1995 - 1996 Corvette: Service Bulletin: Delayed Engagement (Replace Pump Cover Assembly)

Subject: Delayed Engagement (Replace Pump Cover Assembly)

Bulletin Number: 67-71-48

FIGURE 1. - HYDRA-MATIC 4L60-E TRANSMISSION IDENTIFICATION
INFORMATION

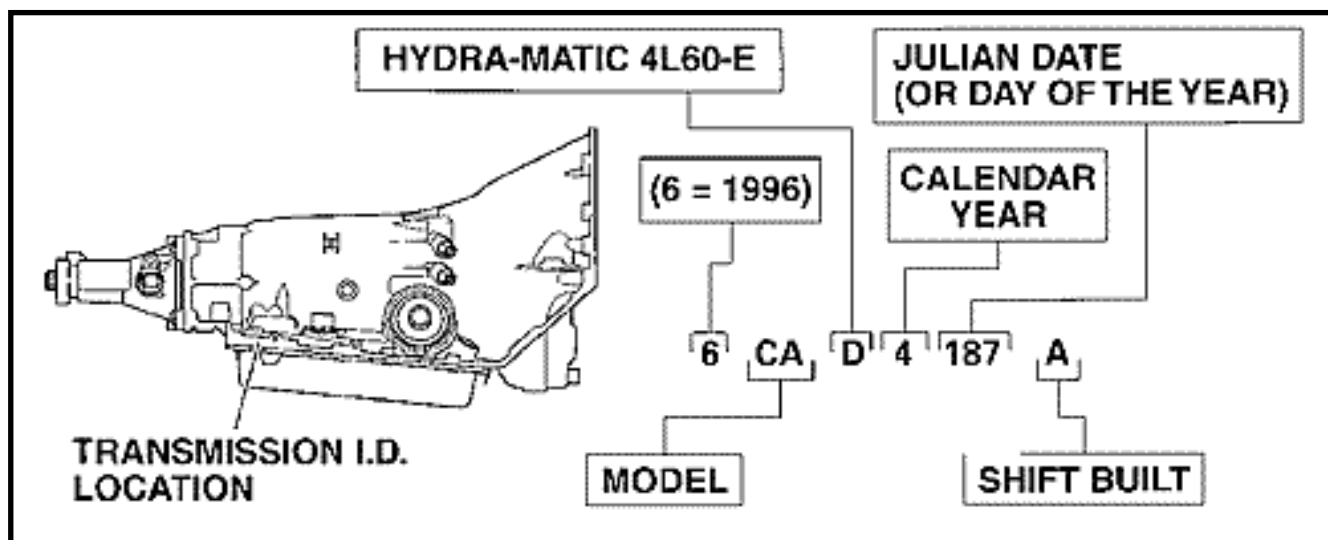
(FIGURES 1 AND 2) SOME OWNERS OF THE ABOVE MODELS, WITH A HYDRA-MATIC 4L60-E TRANSMISSION (BUILT BEFORE APRIL 29, 1996/JULIAN DATE 6120), MAY EXPERIENCE SOME DELAYED ENGAGEMENT WHEN VEHICLE IS NOT USED FOR MORE THAN 48 HOURS.

FIGURE 3. - TORQUE CONVERTER CLUTCH SIGNAL VALVE ASSEMBLY
LOCATION

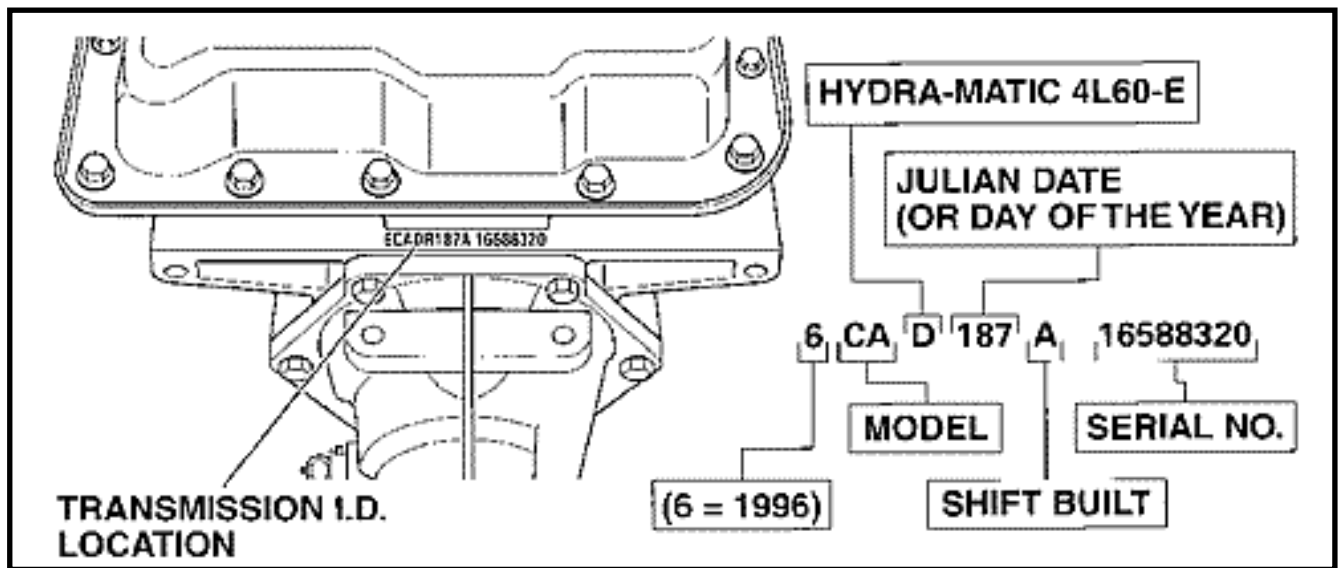
TORQUE CONVERTER FLUID LEVEL LOW DUE TO FLUID DRAIN DOWN.

(FIGURE 3) REPLACE PUMP COVER ASSEMBLY WITH THE NEW TCC SIGNAL VALVE ASSEMBLY.
